CITY OF STAR

LAND USE STAFF REPORT

FILE(S) #: FP-24-02, Final Plat, Naismith Commons Subdivision Phase 3

The Applicant is requesting approval of a Final Plat for Naismith Commons Subdivision Phase 3, consisting of 25 residential lots and 2 common lots on 10.72 acres. The subject property is located at 8895 W. Joplin Road in Star, Idaho, Idaho. Ada County Parcel Number are S0419325800 & S0419314950

NAISMITH COMMONS SUBDIVISION NO. 3

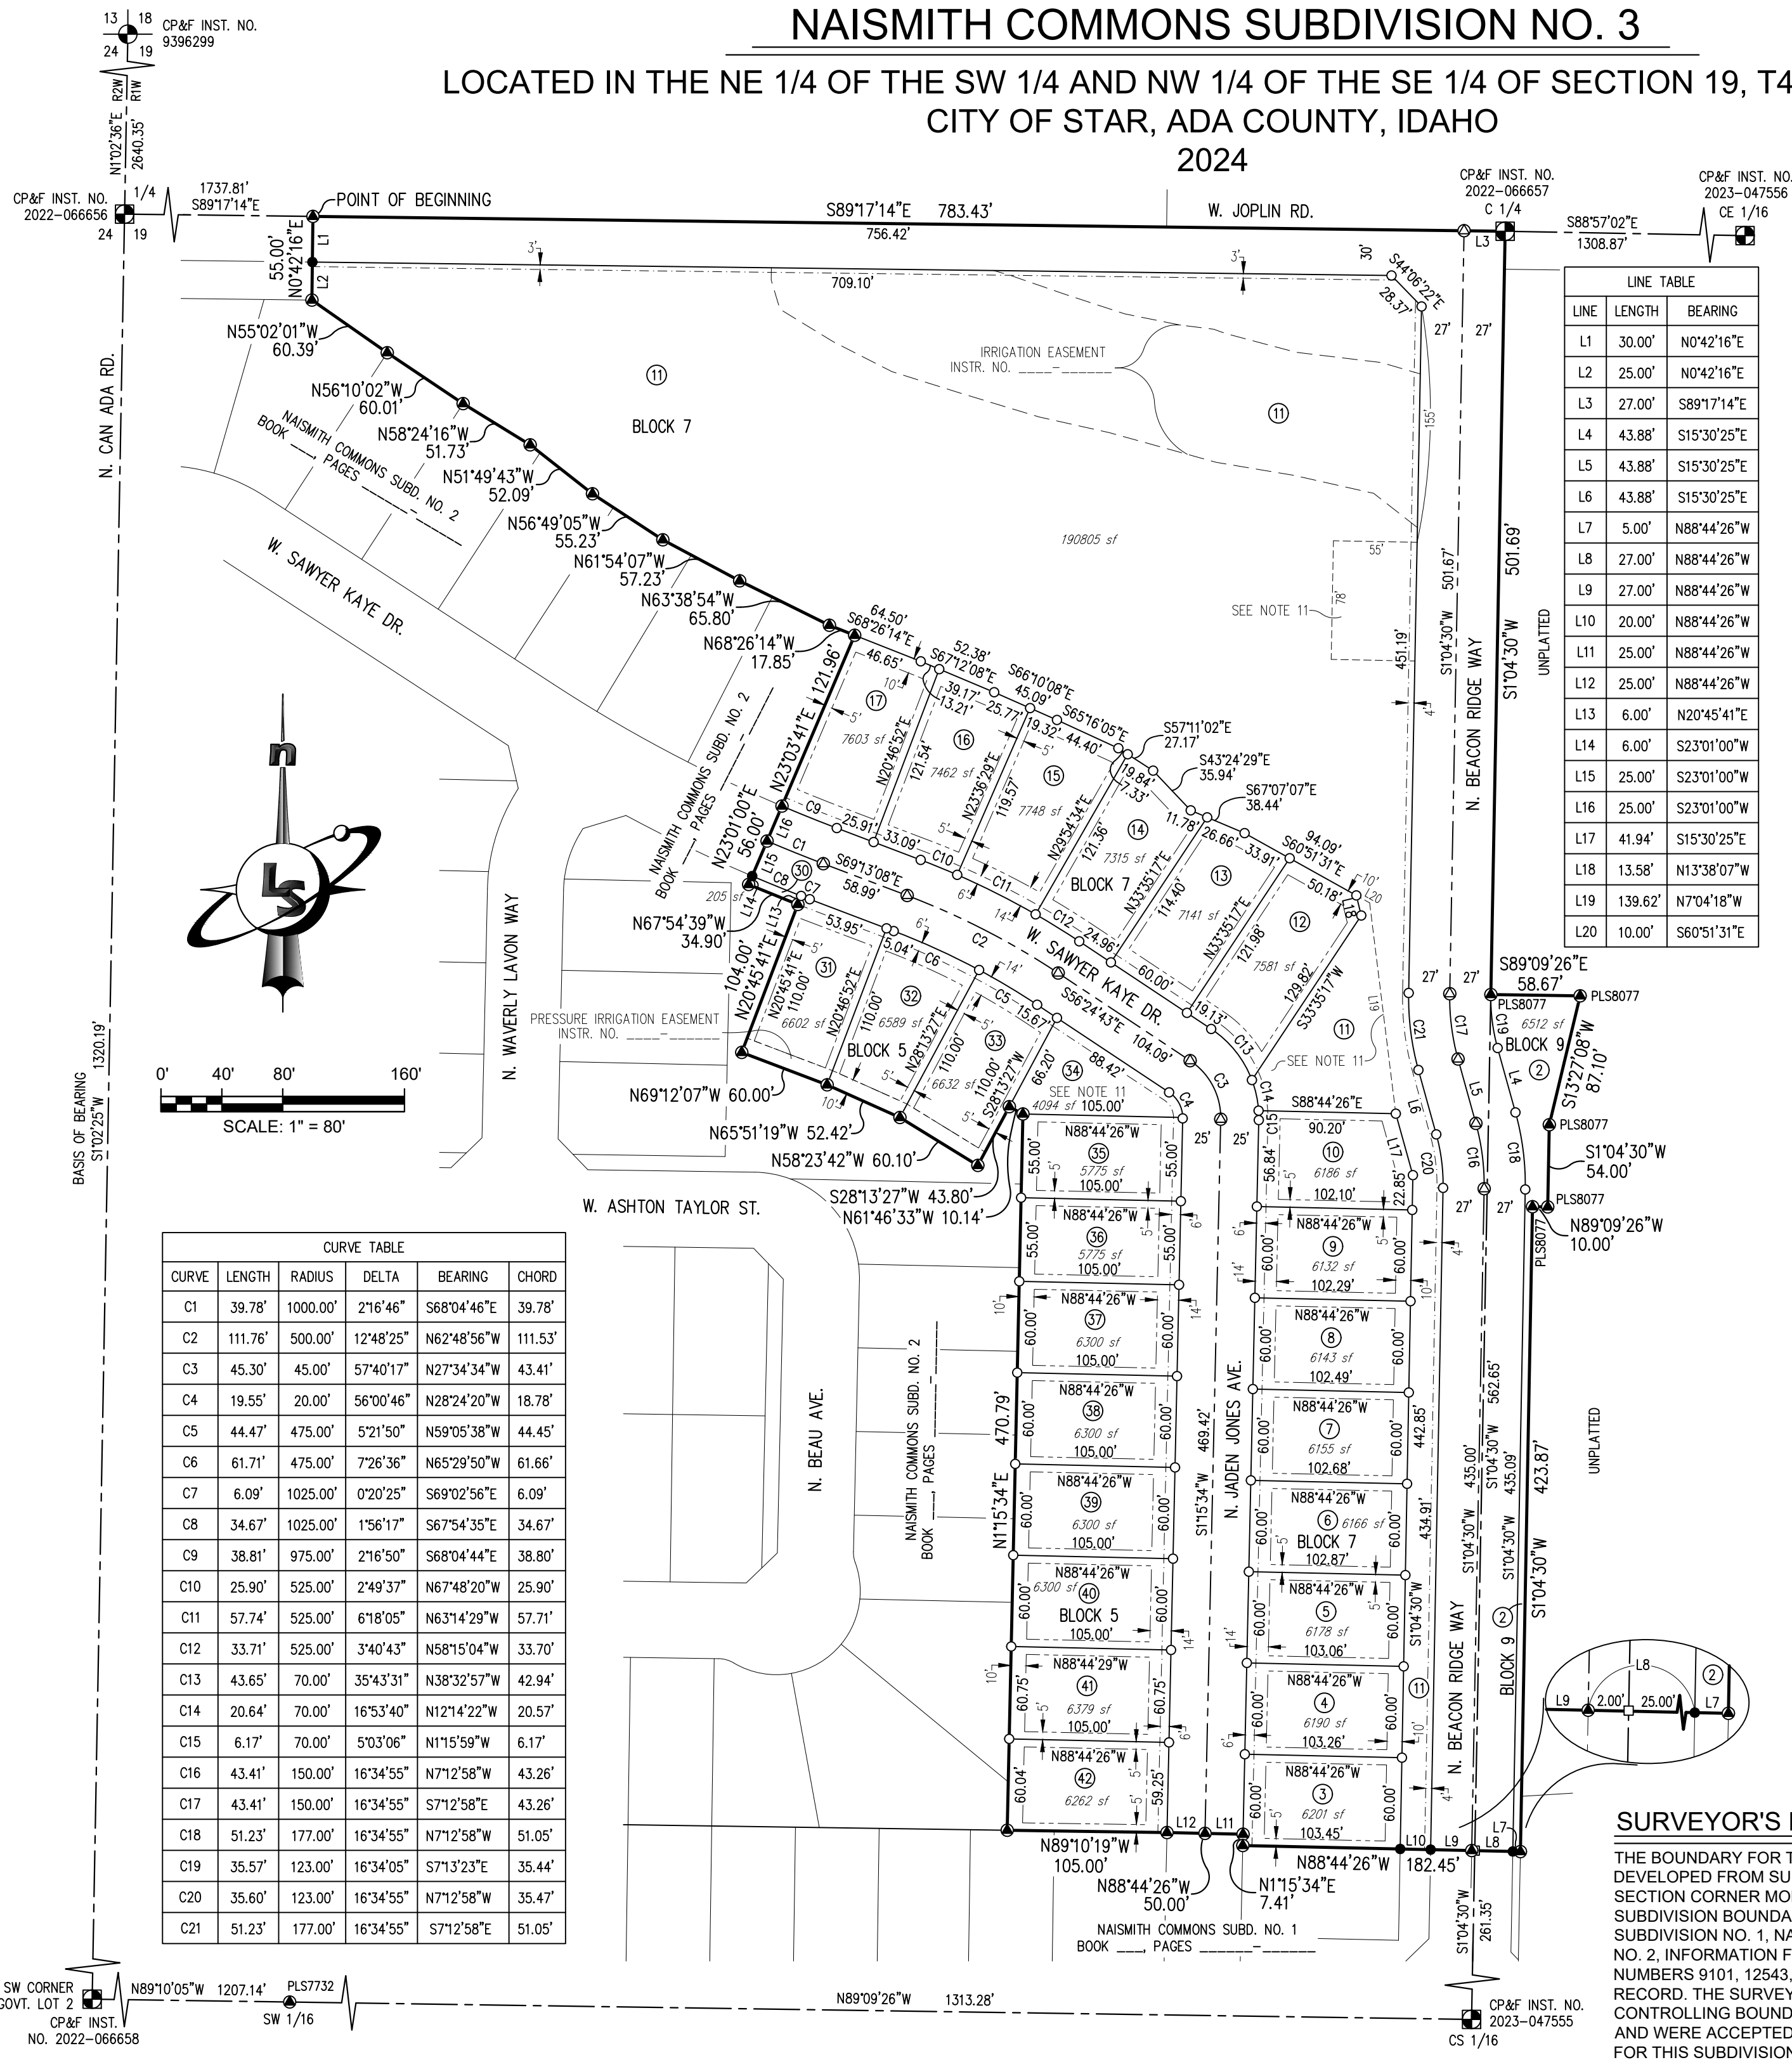
The north-south collector roadway (Beacon Ridge Way), located on the eastern side of the phase shall be revised to show 10' minimum common lots (Lots 1, Blocks 9 & 10) adjacent to the eastern property line. The roadway shall include a detached, 7' sidewalk on the western side of the roadway only. A revised final plat shall be submitted for review.

- D. Provide a revised final plat showing the north-south collector roadway (Beacon Ridge Way), located on the eastern side of the phase with 10' minimum common lots (Lots 1, Blocks 9 & 10) adjacent to the eastern property line. The roadway shall include a detached, 7' sidewalk on the western side of the roadway only.**
